Amendments to the Drawings

Annotated Marked-Up Drawings

**REMARKS**

FIG. 1

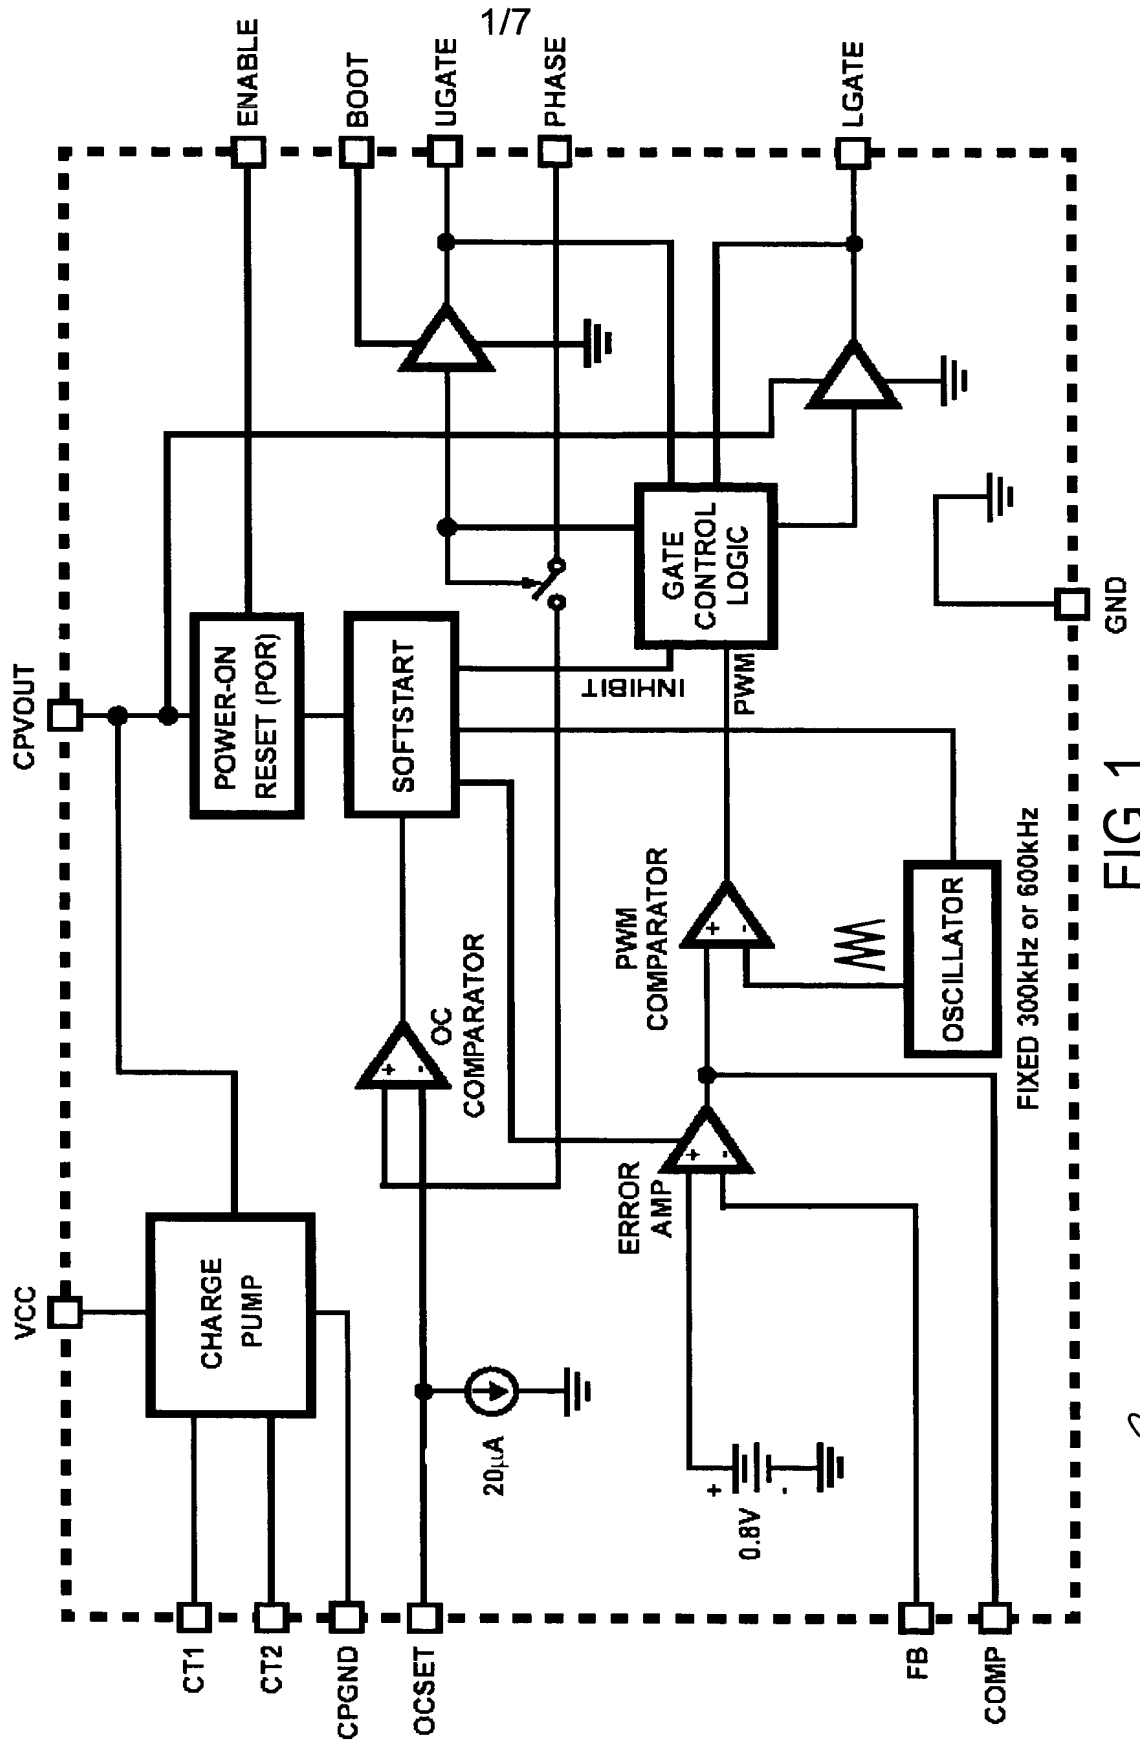
Figures 1, 2, 3, and 12 have been amended to add the word “prior art.”

As requested, Figures 1-3 have been labeled as “prior art.” Figure 12 has also been so labeled. Figure 4 is not considered to be prior art.

*Prior Art*
